04V-253
(13 pages)

Subject: Part 573 Defect and Noncompliance Report

Recall of Featherlite Model 1645 & 1648 Trailers

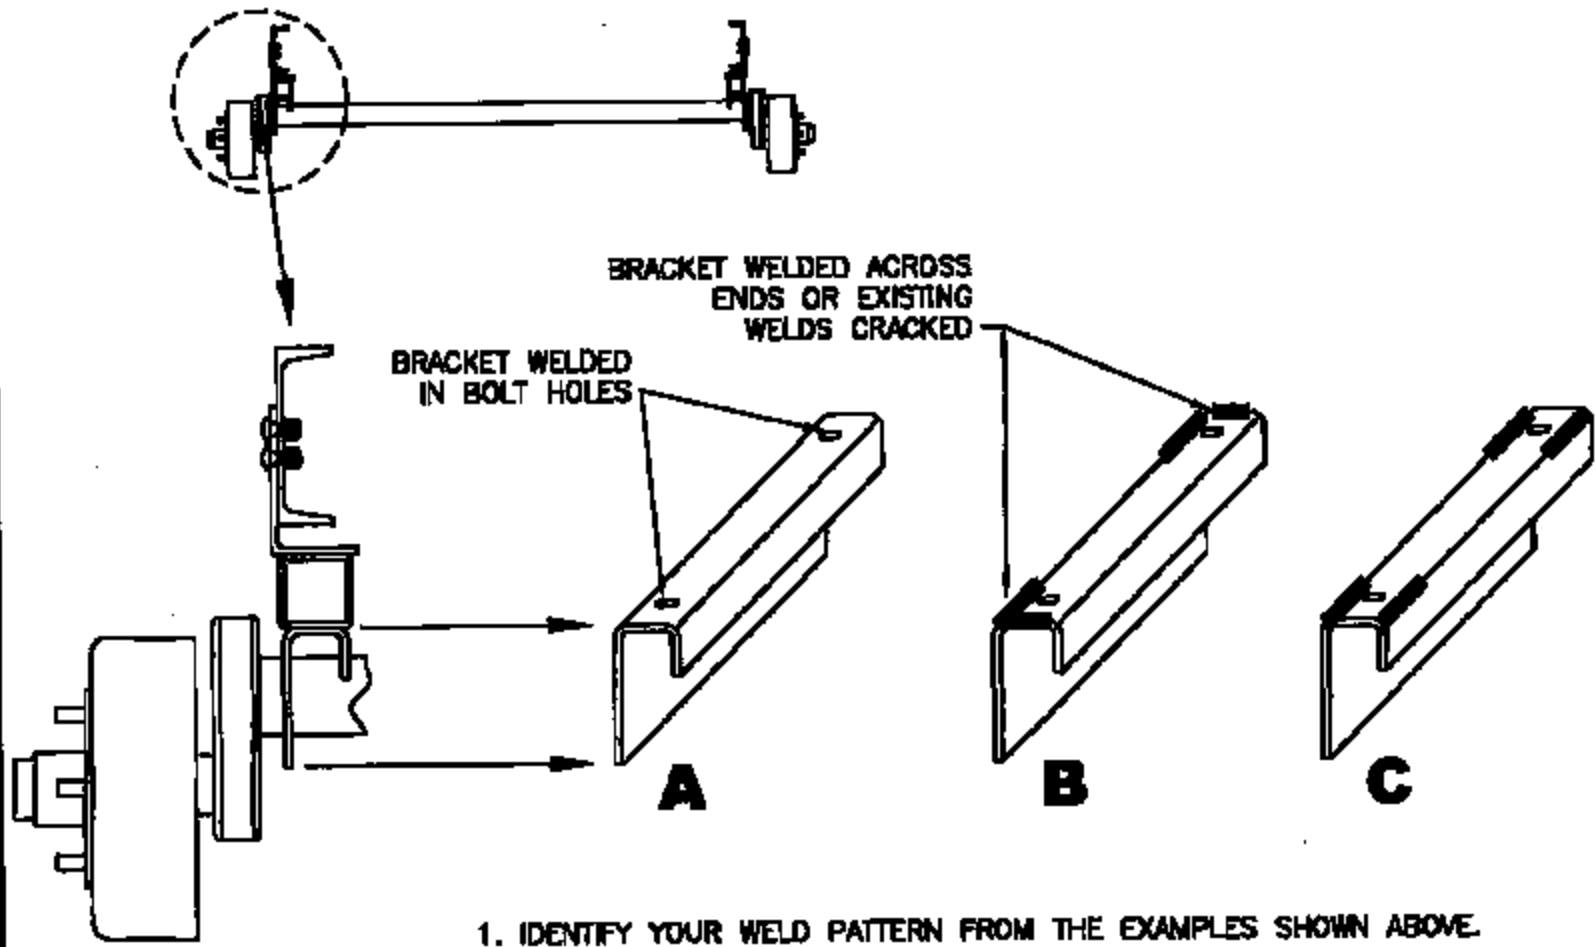
1. IDENTIFY YOUR WELD PATTERN FROM THE EXAMPLES SHOWN ABOVE.
2. IF YOUR TRAILER IS WELDED AS SHOWN IN EITHER OF THE EXAMPLES 'A' OR 'B' ABOVE, OR ANY COMBINATION OF THE TWO, THEN FOLLOW THE REPAIR PROCEDURE ON DRAWING 287824.
3. IF YOUR TRAILER AXLE BRACKET IS WELDED AS SHOWN IN EXAMPLE 'C' ABOVE, NO REPAIR IS REQUIRED.

REPAIR

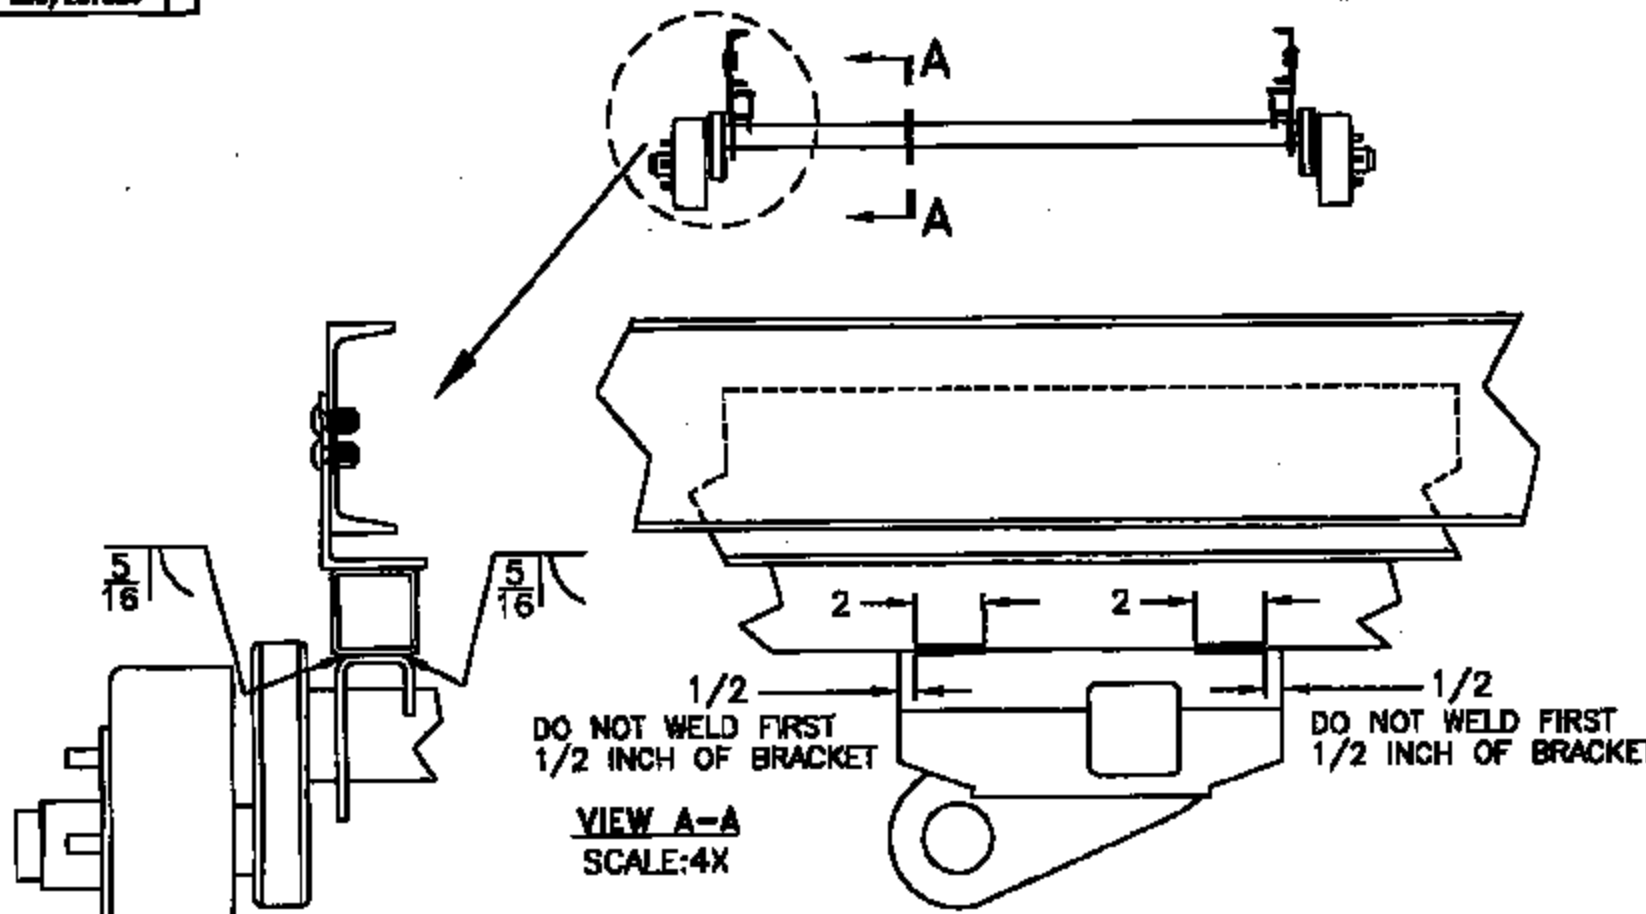
1. INSPECT AND IDENTIFY EXISTING WELDS PER DRAWING NUMBER 287823.
2. IF WELDS ARE NOT PLACED AS SHOWN IN EXAMPLE 'C' ON DWG 287823 ADD THE WELDS SHOWN ON THIS SHEET.
3. EACH AXLE HANGER BRACKET REQUIRES A MINIMUM OF FOUR WELDS: TWO WELDS ON EACH SIDE OF BRACKET, 2 INCHES LONG AND LOCATED AS SHOWN IN VIEW A-A ABOVE.

INSPECT

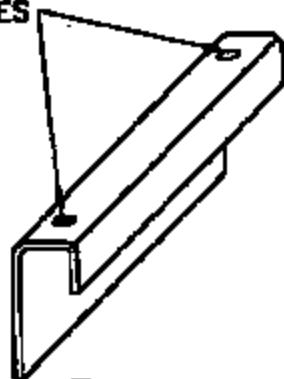
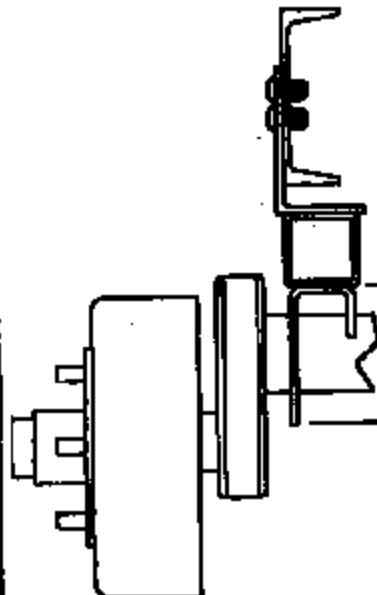
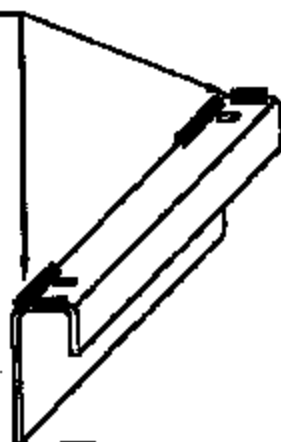
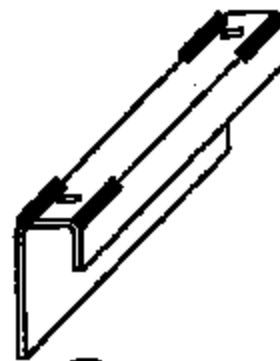
BRACKET WELDED ACROSS
ENDS OR EXISTING
WELDS CRACKED

BRACKET WELDED
IN BOLT HOLES

1. IDENTIFY YOUR WELD PATTERN FROM THE EXAMPLES SHOWN ABOVE.
2. IF YOUR TRAILER IS WELDED AS SHOWN IN EITHER OF THE EXAMPLES 'A' OR 'B' ABOVE, OR ANY COMBINATION OF THE TWO, THEN FOLLOW THE REPAIR PROCEDURE ON DRAWING 287824.
3. IF YOUR TRAILER AXLE BRACKET IS WELDED AS SHOWN IN EXAMPLE 'C' ABOVE, NO REPAIR IS REQUIRED.

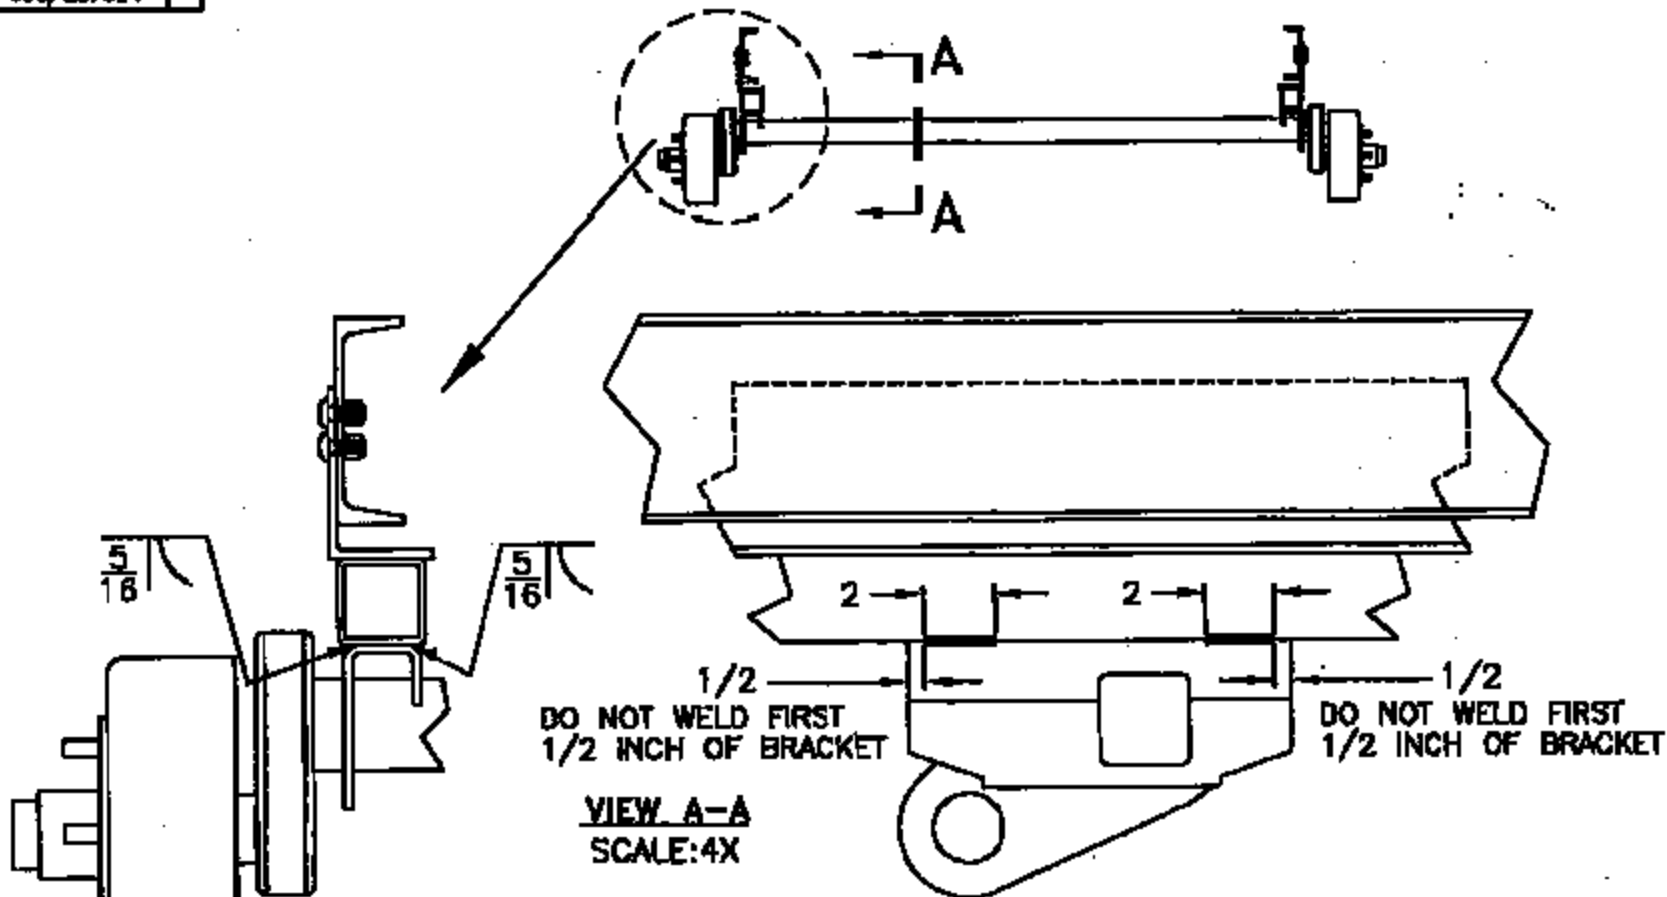
1. INSPECT AND IDENTIFY EXISTING WELDS PER DRAWING NUMBER 287823.
2. IF WELDS ARE NOT PLACED AS SHOWN IN EXAMPLE 'C' ON DWG 287823 ADD THE WELDS SHOWN ON THIS SHEET.
3. EACH AXLE HANGER BRACKET REQUIRES A MINIMUM OF FOUR WELDS: TWO WELDS ON EACH SIDE OF BRACKET, 2 INCHES LONG AND LOCATED AS SHOWN IN VIEW A-A ABOVE.

INSPECT

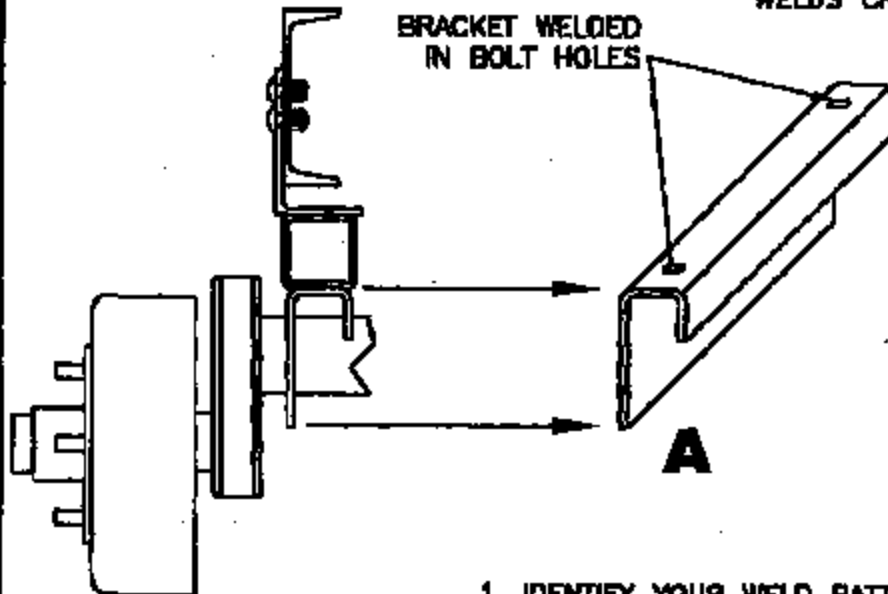
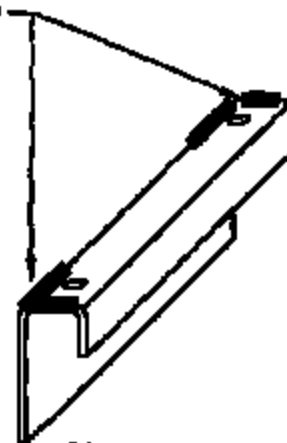
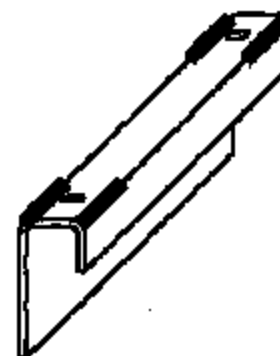
BRACKET WELDED ACROSS
ENDS OR EXISTING
WELDS CRACKED

BRACKET WELDED
IN BOLT HOLES

1. IDENTIFY YOUR WELD PATTERN FROM THE EXAMPLES SHOWN ABOVE.
2. IF YOUR TRAILER IS WELDED AS SHOWN IN EITHER OF THE EXAMPLES 'A' OR 'B' ABOVE, OR ANY COMBINATION OF THE TWO, THEN FOLLOW THE REPAIR PROCEDURE ON DRAWING 287824.
3. IF YOUR TRAILER AXLE BRACKET IS WELDED AS SHOWN IN EXAMPLE 'C' ABOVE, NO REPAIR IS REQUIRED.
